SERVICE BULLETIN

N° 139-577

ATA 53 – LOWER INSPECTION COVER INSTALLATION

This Service Bulletin is issued in order to provide the necessary instructions on how to perform the installation of lower inspection cover STA 3900/5700.

Figure 1

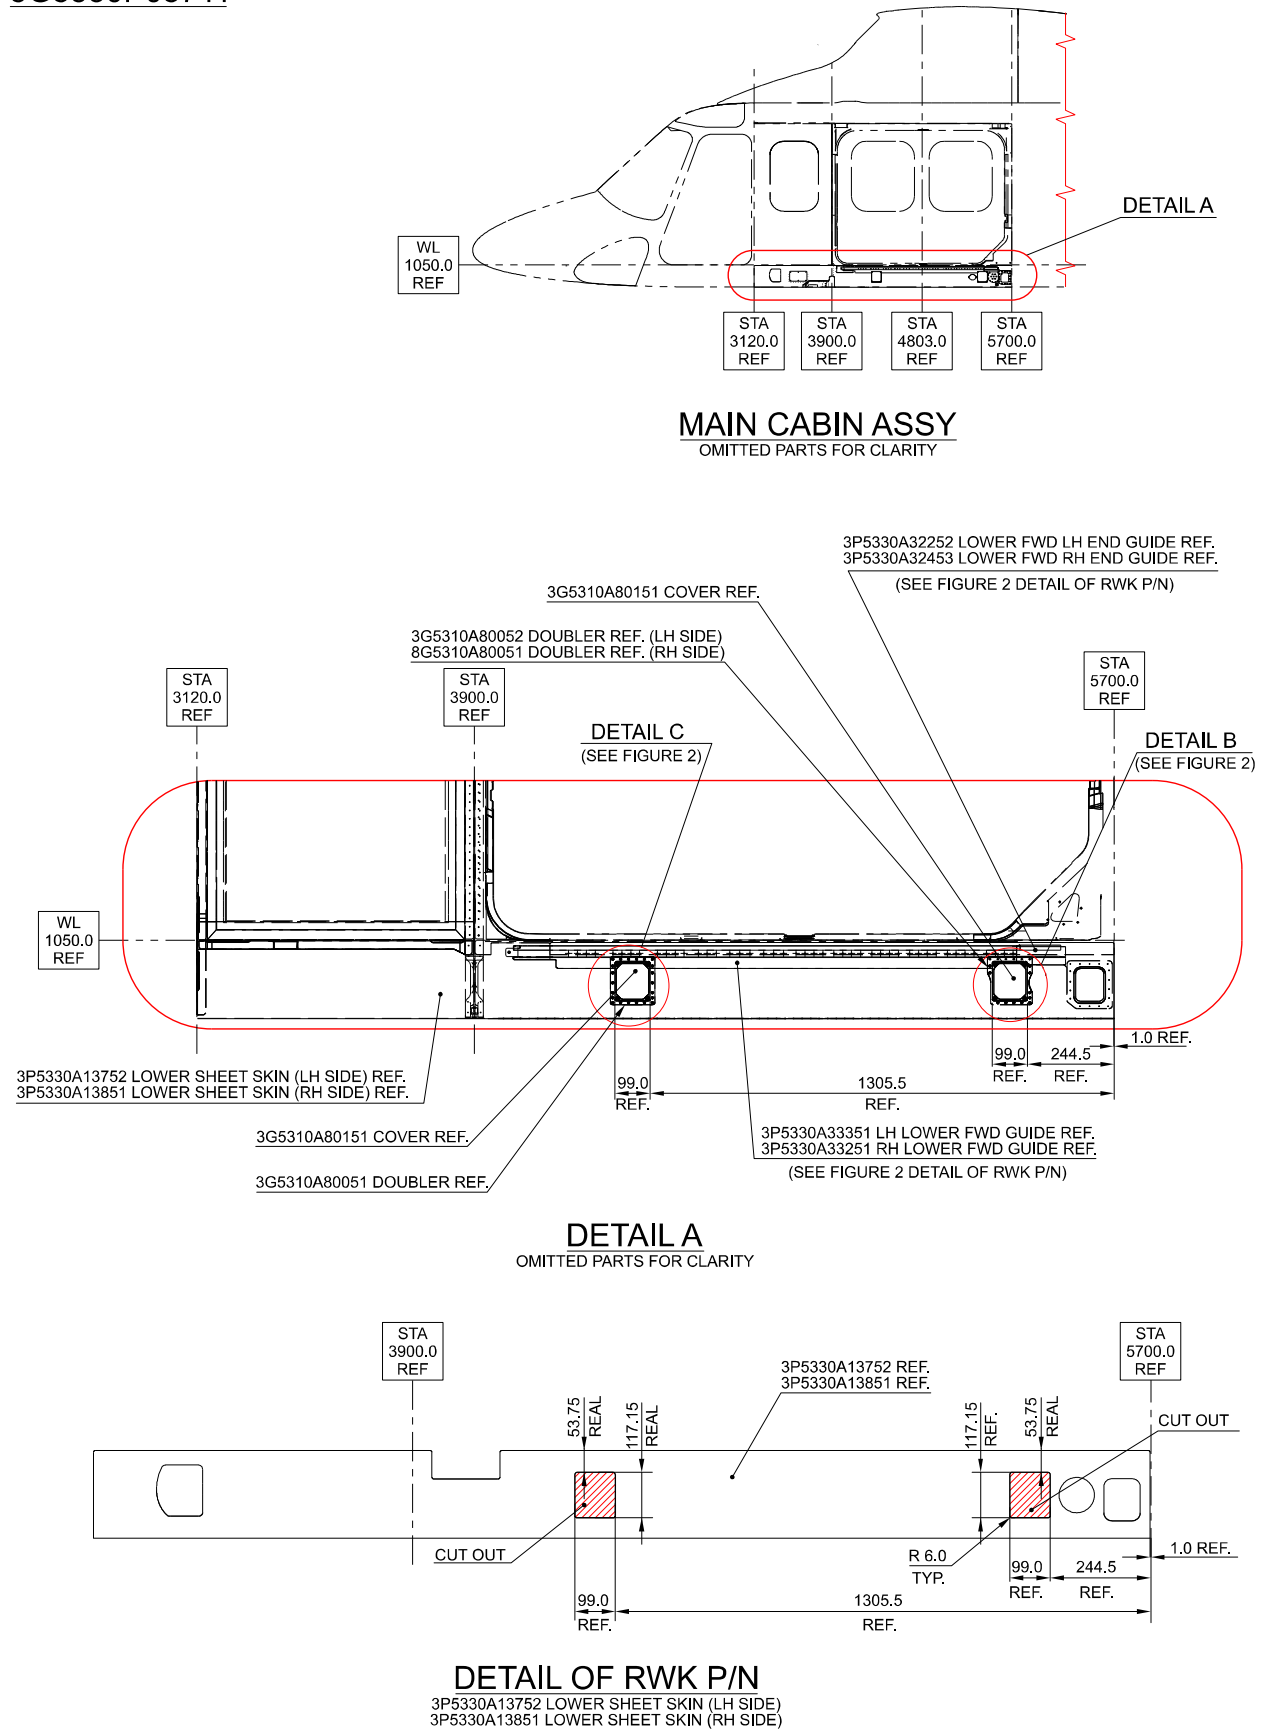
1. In accordance with AMP DM 39-A-00-20-00-00A-120A-A prepare the helicopter on ground for a safe maintenance. Disconnect the battery, all electrical power sources and/or the external power supply.
2. In accordance with AMP DM 39-A-06-41-00-00A-010A-A and with reference to Figure 1 and 2, gain access to the area affected by installation and perform lower inspection cover STA 3900/5700 retromod P/N 3G5330P05711 as described in the following procedure:
 - 2.1 In accordance with AMP DM 39-A-52-12-01-00A-520A-A, remove the cabin door LH from the helicopter.
 - 2.2 With reference to Figure 1 Detail A, remove the existing fasteners that attach the LH lower FWD guide P/N 3P5330A33351 to the LH lower sheet skin P/N 3P5330A13752. Keep them for later reuse.
 - 2.3 With reference to Figure 1 Detail A, remove the LH lower FWD guide

- 2.4 With reference to Figure 2 Detail B, remove the reinforcement P/N 3P5330A32551.
- 2.5 With reference to Figure 1 Detail of RWK P/N, perform n°2 cut-outs on the lower sheet skin LH P/N 3P5330A13752.
- 2.6 With reference to Figure 2 Detail of RWK P/N, perform n°2 cut-outs on the LH lower FWD guide P/N 3P5330A33351.
- 2.7 With reference to Figure 2 Detail of RWK P/N, perform the indicated cut-out on the FWD LH end guide P/N 3P5330A32252.

- 2.9 With reference to Figure 1 Detail A and Figure 2 Detail B, install n°4 anchor nuts P/N MS21073L08 on the doubler P/N 3G5310A80052 by means of n°8 rivets P/N MS20426AD3-4.

- 2.10 With reference to Figure 1 Detail A and Figure 2 Detail B, temporarily locate the doubler P/N 3G5310A80052 on the LH lower sheet skin P/N 3P5330A13752, countermark and drill n°17 rivet holes thru the skin.

- 2.11 With reference to Figure 1 Detail A and Figure 2 Detail B, install the doubler P/N 3G5310A80052 on the LH lower sheet skin P/N 3P5330A13752 by means of n°16 rivets P/N MS20470AD4-4 and the rivet P/N MS20426AD4-4.

- 2.12 With reference to Figure 1 Detail A and Figure 2 Detail B, fill all around the doubler P/N 3G5310A80052 by means of the Naftoseal MC-780 (C355).

- 2.13 With reference to Figure 1 Detail A and Figure 2 Detail B, install the cover P/N 3G5310A80151 on the doubler P/N 3G5310A80052 by means of n°4 screws P/N AN525-832R6.

- 2.14 With reference to Figure 1 Detail A and Figure 2 Detail B, apply the sealant (C347) along the perimeter of the cover P/N 3G5310A80151.
- 2.15 With reference to Figure 1 Detail A and Figure 2 Detail C, install n°4 anchor nuts P/N MS21073L08 on the doubler P/N 3G5310A80051 by means of n°8 rivets

- P/N MS20426AD3-4.
- 2.16 With reference to Figure 1 Detail A and Figure 2 Detail C, temporarily locate the doubler P/N 3G5310A80051 on the LH lower sheet skin P/N 3P5330A13752, countermark and drill n°22 rivet holes thru the skin.
 - 2.17 With reference to Figure 1 Detail A and Figure 2 Detail C, install the doubler P/N 3G5310A80051 on the LH lower sheet skin P/N 3P5330A13752 by means of n°22 rivets P/N MS20470AD4-4.
 - 2.18 With reference to Figure 1 Detail A and Figure 2 Detail C, fill all around the doubler P/N 3G5310A80051 by means of the Naftoseal MC-780 (C355).
 - 2.19 With reference to Figure 1 Detail A and Figure 2 Detail C, install the cover P/N 3G5310A80151 on the doubler P/N 3G5310A80051 by means of n°4 screws P/N AN525-832R6.
 - 2.20 With reference to Figure 1 Detail A and Figure 2 Detail C, apply the sealant (C347) along the perimeter of the cover P/N 3G5310A80151.

- 2.23 With reference to Figure 1, install the LH lower FWD guide P/N 3P5330A33351 on the LH lower sheet skin P/N 3P5330A13752 by means of retained hardware.

- 2.24 With reference to Figure 1, install the lower FWD LH end guide P/N 3P5330A32252 on the LH lower sheet skin P/N 3P5330A13752 by means of retained hardware.

- 2.27 With reference to Figure 1 Detail A, remove the existing fasteners that attach the RH lower FWD guide P/N 3P5330A33251 to the RH lower sheet skin

- 2.28 With reference to Figure 1 Detail A, remove the RH lower FWD guide P/N 3P5330A33251 and the lower FWD RH end guide P/N 3P5330A32452 from the helicopter. Keep hardware from later reuse.

Figure 2

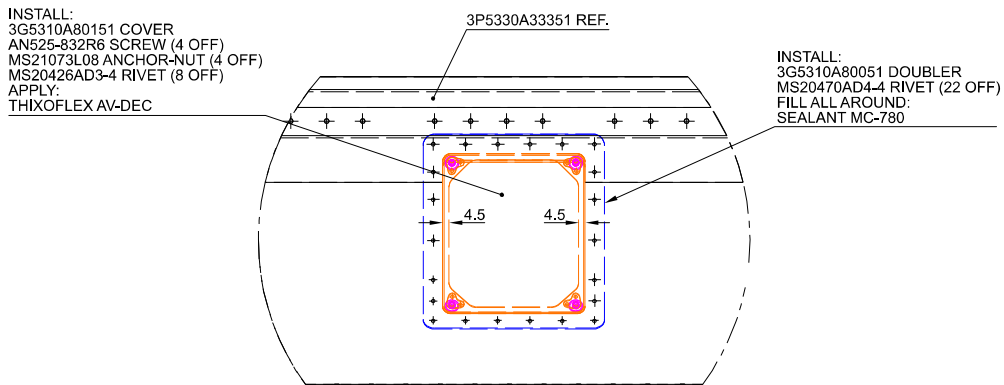
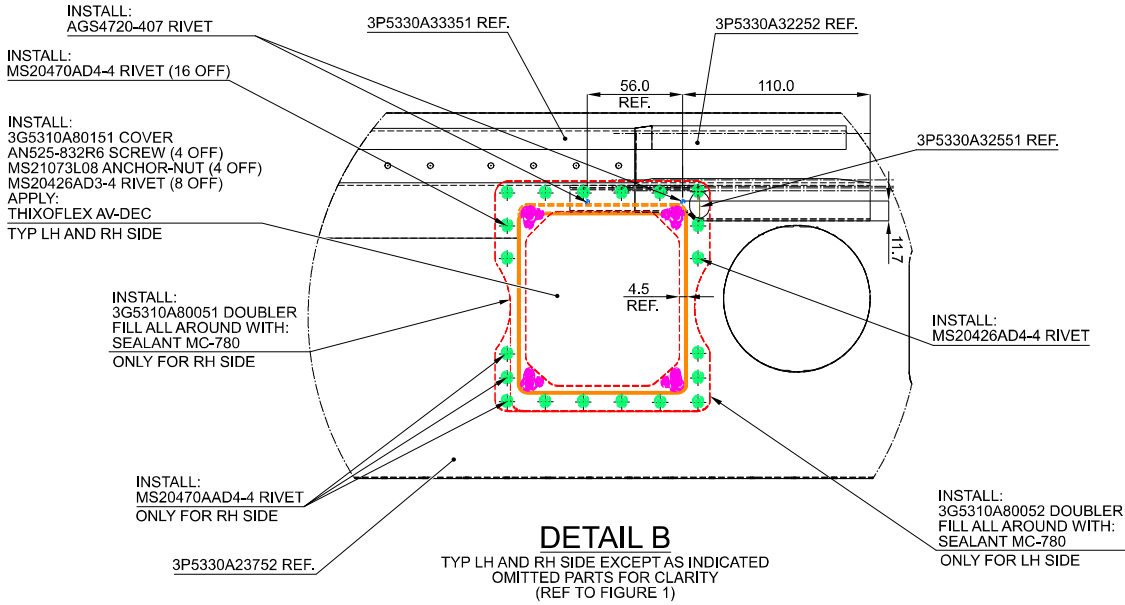
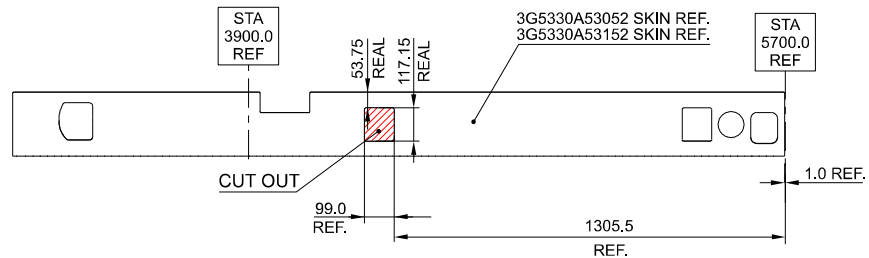
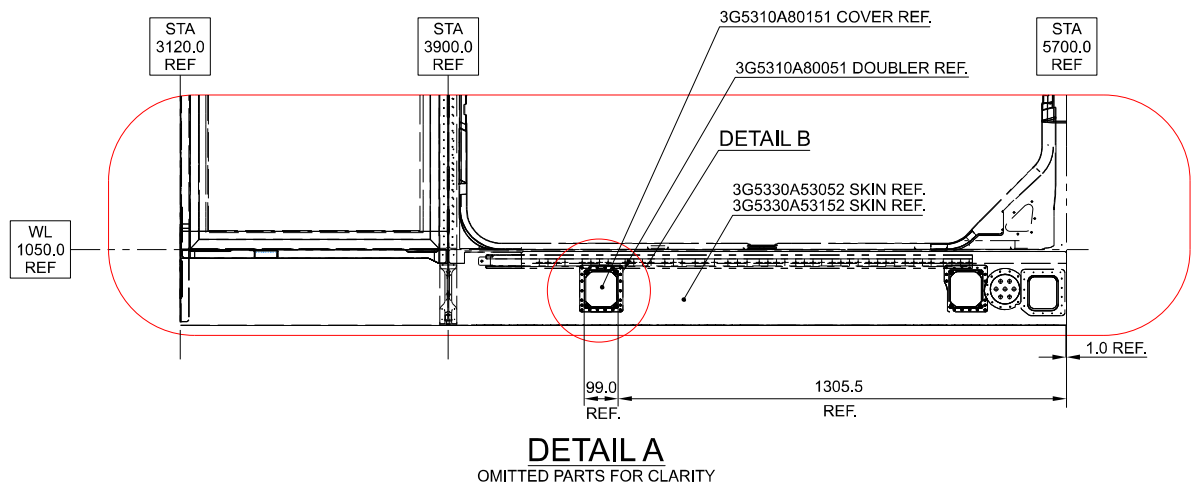
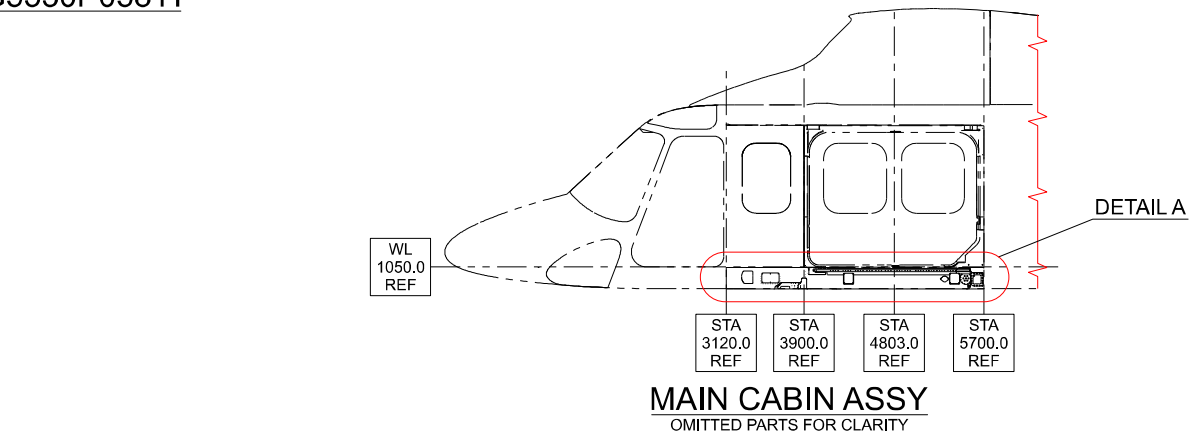
- 2.8 With reference to Figures 1 and 2, perform the cut-out of the reinforcement P/N 3P5330A32551 in accordance with the previously performed cut-outs.

- 2.21 With reference to Figure 2 Detail B, temporarily locate the reinforcement P/N 3P5330A32551 in its position on the LH lower sheet skin P/N 3P5330A13752 and drill n°2 rivet holes in accordance with the dimensioning shown.

- 2.22 With reference to Figure 2 Detail B, install the reinforcement P/N 3P5330A32551 on the LH lower sheet skin P/N 3P5330A13752 by means of n°2 rivets P/N AGS4720-407.

- 2.38 With reference to Figure 2 Detail B, temporarily locate the reinforcement P/N 3P5330A32551 in its position on the RH lower sheet skin P/N 3P5330A13851 and drill n°2 rivet holes in accordance with the dimensioning shown.

- 2.39 With reference to Figure 2 Detail B, install the reinforcement P/N 3P5330A32551 on the RH lower sheet skin P/N 3P5330A13851 by means of n°2 rivets P/N AGS4720-407.

Figure 3

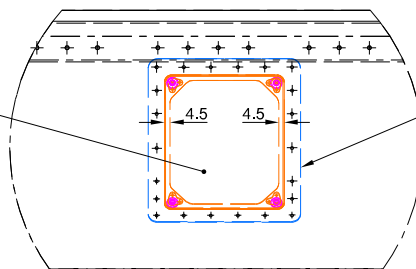
2. In accordance with AMP DM 39-A-06-41-00-00A-010A-A and with reference to Figure 3, gain access to the area affected by installation and perform lower inspection cover STA 3900 retromod P/N 3G5330P05811 as described in the following procedure:

- 2.1 With reference to Figure 3 Detail of RWK P/N, perform n°2 cut-outs on the skin LH P/N 3G5330A53052.
 - 2.2 With reference to Figure 3 Detail A and Detail B, install n°4 anchor nuts P/N MS21073L08 on the doubler P/N 3G5310A80051 by means of n°8 rivets P/N MS20426AD3-4.

- 2.3 With reference to Figure 3 Detail A and Detail B, temporarily locate the doubler P/N 3G5310A80051 on the skin LH P/N 3G5330A53052, countermark and drill n° 22 rivet holes.

- 2.4 With reference to Figure 3 Detail A and Detail B, install the doubler P/N 3G5310A80051 on the skin LH P/N 3G5330A53052 by means of n°22 rivets P/N MS20470AD4-4.

- 2.5 With reference to Figure 3 Detail A and Detail B, fill all around the doubler P/N 3G5310A80051 by means of the Naftoseal MC-780 (C355).
 - 2.6 With reference to Figure 3 Detail A and Detail B, install the cover P/N 3G5310A80151 on the doubler P/N 3G5310A80051 by means of n°4 screws P/N AN525-832R6.

- 2.7 With reference to Figure 3 Detail A and Detail B, apply the sealant (C347) along the perimeter of the cover P/N 3G5310A80151.
 - 2.8 With reference to Figure 3 Detail of RWK P/N, repeat step 2.1 to rework the skin RH P/N 3G5330A53152.

- 2.9 With reference to Figure 3, repeat steps from 2.2 thru 2.8 to install the cover P/N 3G5310A80151 and the doubler P/N 3G5310A80051 on the RH side.

INSTALL:
3G5310A80151 COVER
AN525-332R6 SCREW (4 OFF)
MS21073L08 ANCHOR-NUT (4 OFF)
MS20426AD3-4 RIVET (8 OFF)
APPLY:
THIXOFLEX AV-DEC

INSTALL:
3G5310A80051 DOUBLER
MS20470AD4-4 RIVET (22 OFF)
FILL ALL AROUND WITH:
SEALANT MC-780
